**INTERROGATORY #1**

**IESO SIA CAA ID-2005-196**  
**Powerline MTS**  
**November 29, 2005**

# System Impact Assessment Report

Figure 3. Powerline TS - Recommended Facilities with Normally Open Tie Switches

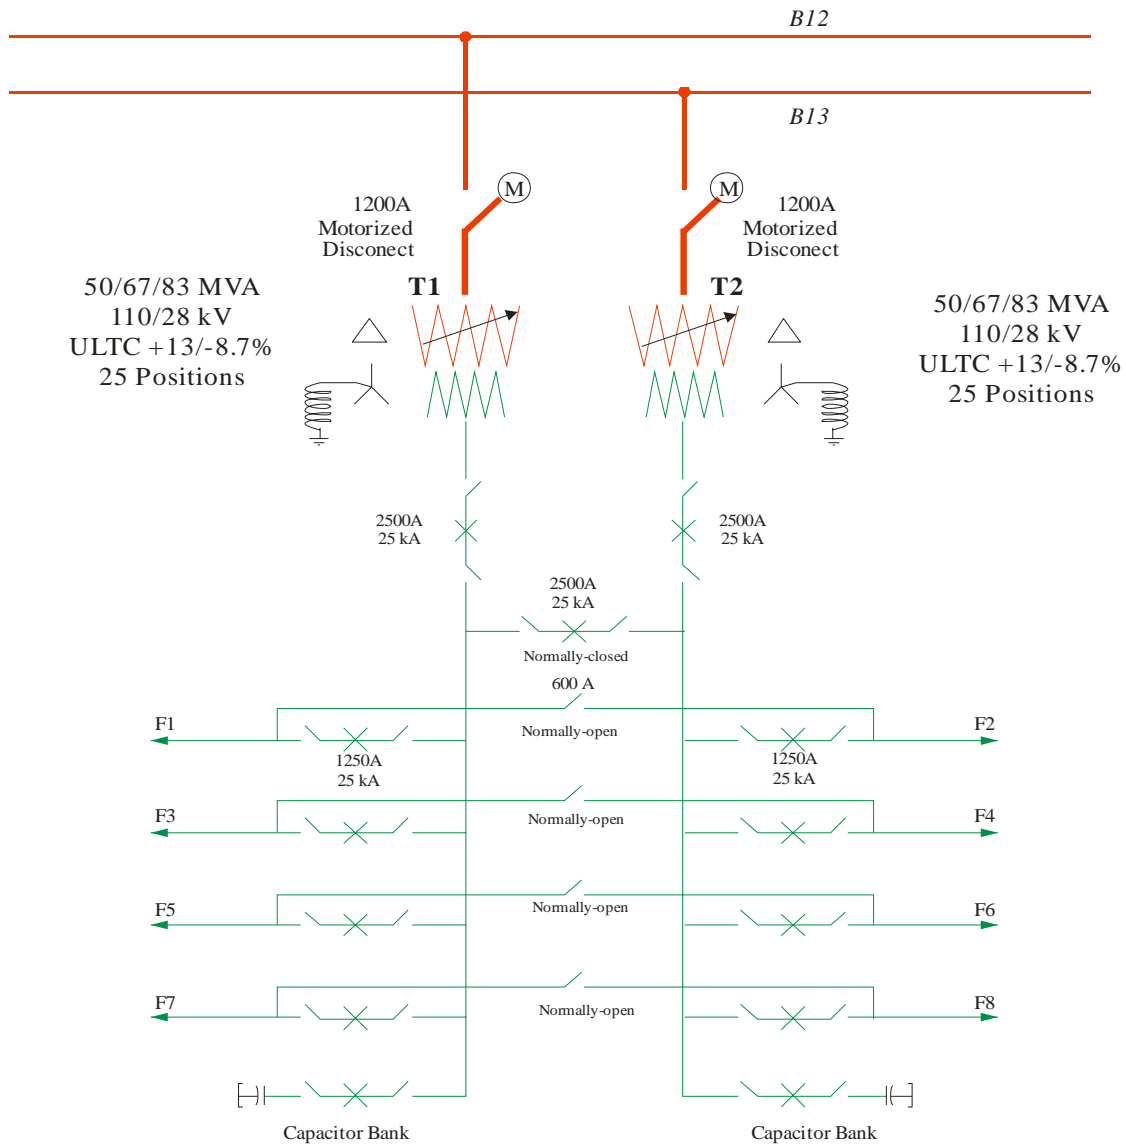
It should be noted that a typical simple DESN arrangement includes feeder tie switches that are operated normally open, as shown in Figure 3.

IESO recommends that feeder tie switches, that are to be operated normally open, be installed at the new DESN. This arrangement will provide additional load supply flexibility under emergency or maintenance situations by allowing two feeders to be connected to the same LV breaker position.
